*Environmental Assessment for the  
Decontamination, Demolition, and  
Removal of Certain Facilities at the  
West Valley Demonstration Project*

Final

U.S. Department of Energy  
West Valley Demonstration Project  
West Valley, New York

## **APPENDIX D     DOE'S RESPONSE TO COMMENTS**

**Figure 1. Location of the West Valley Demonstration Project and Western New York Nuclear Service Center (WNYNSC)**

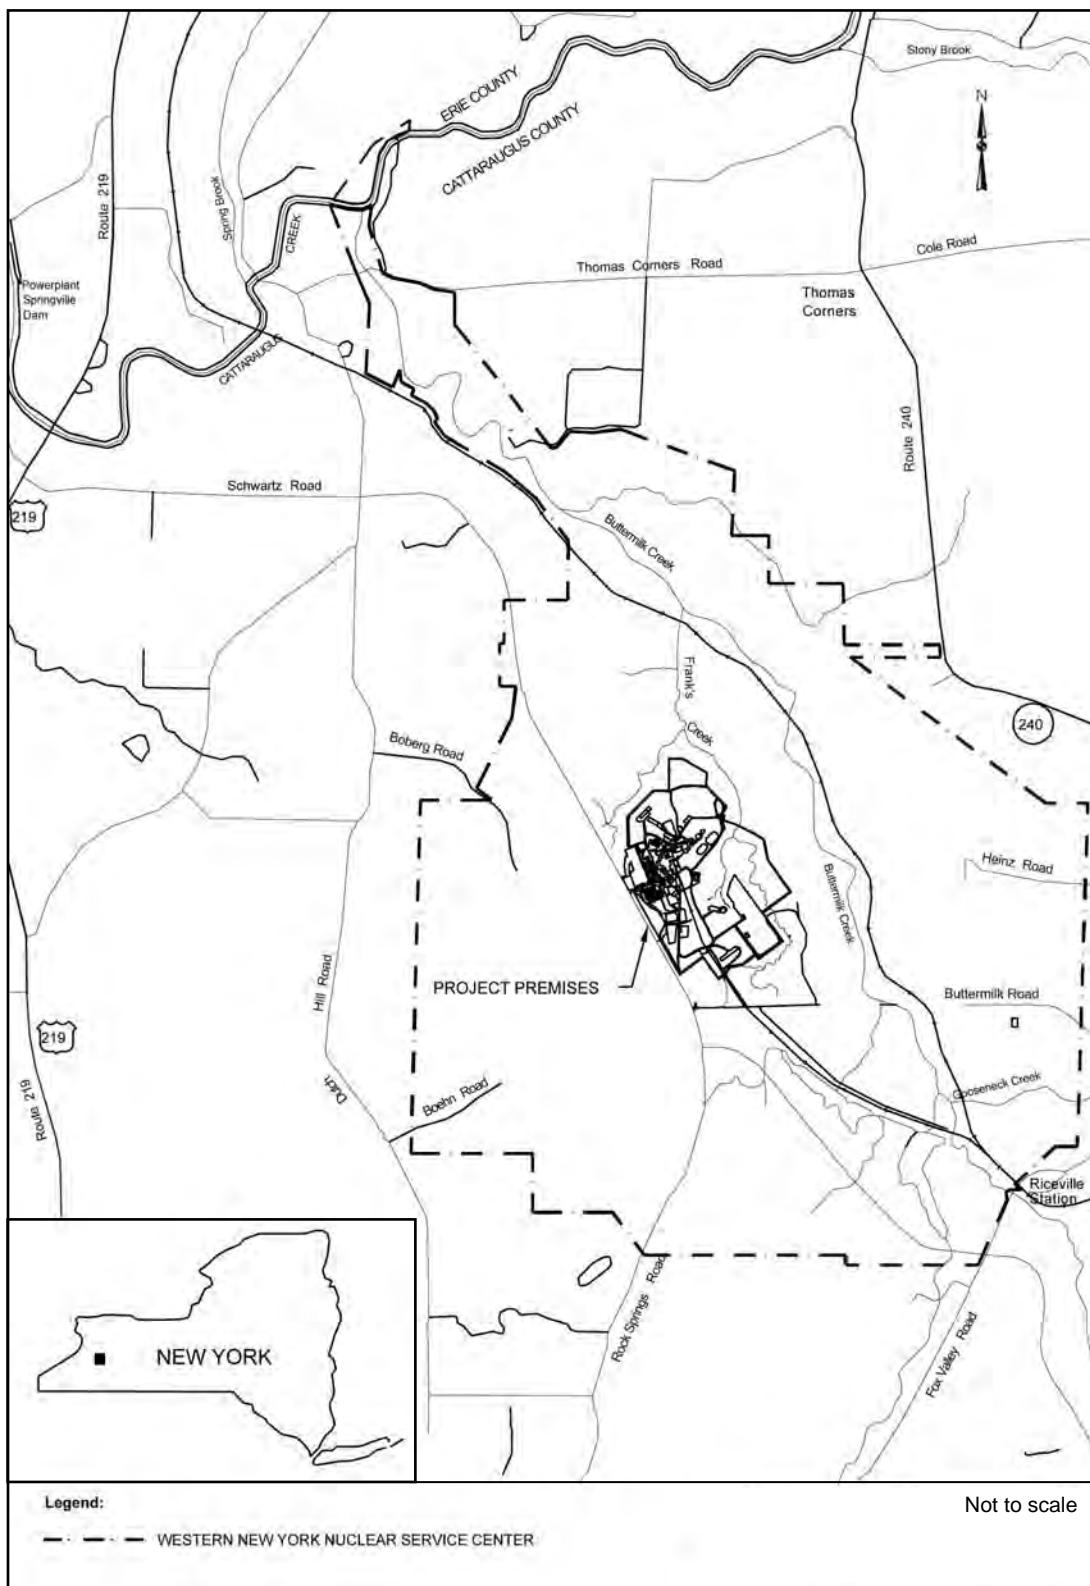
4. Site Terminology Box, Page 3, and Figures 1, and 2. The Project Premises includes all land and structures over which DOE has sole use and control. In addition to the areas described in the description and figure in question, the rail spur, live-fire range, reservoirs, and Bulk Storage Warehouse are part of the Project Premises. Descriptions of the Premises, both written and visual, should make this clear. } 7-11

<b>Commenter / Comment Number</b>	<b>Comment</b>	<b>DOE Response</b>
	Project Premises. Descriptions of the Premises, both written and visual, should make this clear.	two subsequent letters as referenced in the WVDP 6 NYCRR Part 373-2 Hazardous Waste Permit Application (WVDP-443). The rail spur on the WNYNSC retained premises, reservoirs, and the Bulk Storage Warehouse have been used by DOE in conducting the WVDP, but are not officially cited as Project Premises. The purpose of Figure 1 is to show the relative location of WVDP and WNYNSC within the State of New York and in reference to each other. Figure 2 does not attempt to show every building and facility within the WVDP site.
7-12	<p><u>Section 2.1</u> This section states that “DOE needs to eliminate or significantly reduce the functions that are undertaken in those facilities” being proposed for removal on the EA. DOE does not explain why it “needs to” remove all LLRW storage capacity, the onsite emergency response and sanitary facilities, or the specialized training and maintenance facilities. Nor does it explain why it “needs” to remove the new warehouse. The only language supporting removal appears to be the statement that DOE “needs” to do so. If there were no reasonably expected future use for these facilities, then it would be rational to say that their continued use was no longer needed. However, that is not the case for these facilities.</p>	<p>Since the issuance of the draft EA, DOE has determined that six structures (plus one of the two Waste Tank Farm training platforms) originally proposed for demolition and removal could be needed under future decommissioning and/or closure scenarios or to address currently unresolved needs and, for that reason, has eliminated those buildings from the scope of the final EA. The structures that have been removed from the scope of the EA include LLW and TRU waste storage capacity, sanitary facilities, specialized training and maintenance facilities, and the new warehouse. They will be included in the Decommissioning EIS. There is no reasonably expected future use for the 36 facilities that remain in the scope of the EA. Additional language to this effect was added to the EA.</p> <p>The emergency response program at the WVDP would not be affected by removing the Emergency Vehicle Shelter. The emergency response vehicle would remain available and fully stocked, and existing agreements with local response organizations would remain in effect. However, to address the concern raised in this comment, the EA has been revised to reflect the fact that the emergency response vehicle could be stored outside or in another existing facility.</p>

**Figure 2. WVDP Site Map (Project Premises)**

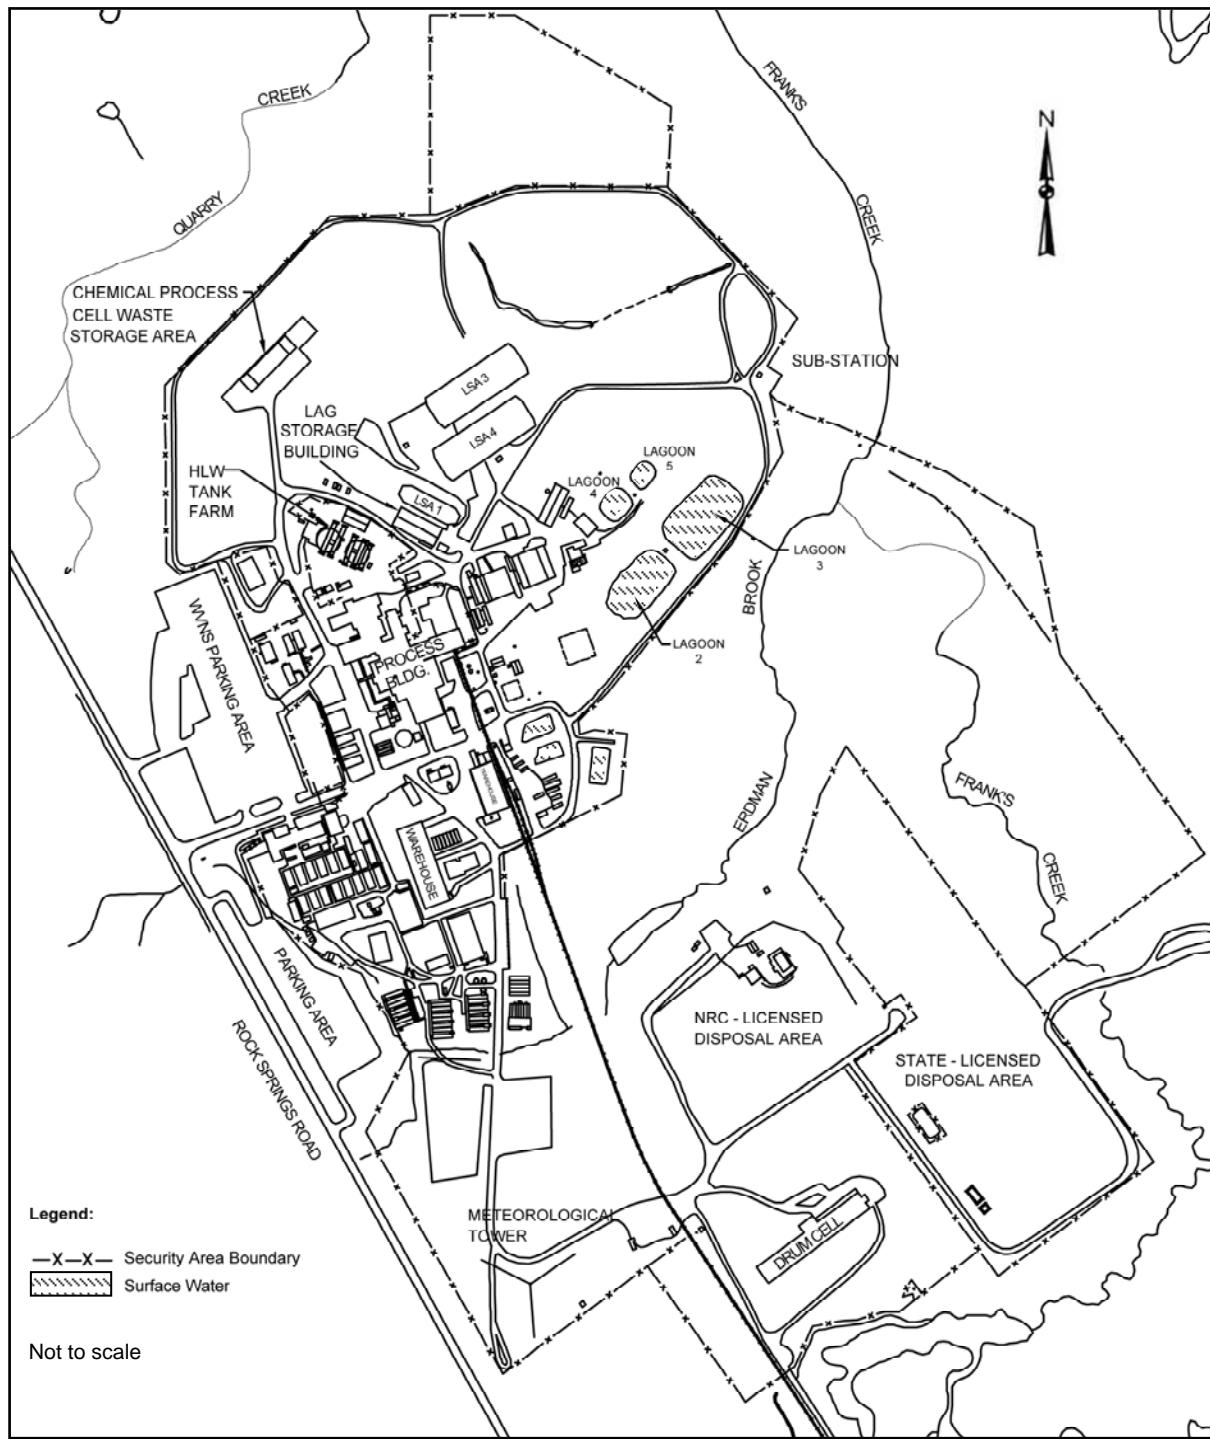
7-10	<p><u>Figure 2</u> This map does not include areas in Waste Management Areas (WMA) 11 and 12. An inclusive map of the entire West Valley Demonstration Project (W\TDP) premises should be provided.</p>	<p>The Waste Management Areas are shown in Figures 3 and 4.</p>
7-11	<p><u>Site Terminology Box, Page 3, and Figures 1. and 2.</u> The Project Premises includes all land and structures over which DOE has sole use and control. In addition to the areas described in the description and figure in question, the rail spur, live-fire range, reservoirs, and Bulk Storage Warehouse are part of the</p>	<p>The Site Terminology box accurately describes the activities undertaken in carrying out the solidification of liquid high-level radioactive waste (HLW) at the WNYNSC and is not an attempt to list every component of the site. The official Project Premises are defined by the DOE-NYSERDA Cooperative Agreement and by</p>

3. Figure 2 This map does not include areas in Waste Management Areas (WMA) 11 and 12. An inclusive map of the entire West Valley Demonstration Project (WVDP) premises should be provided. } 7-10
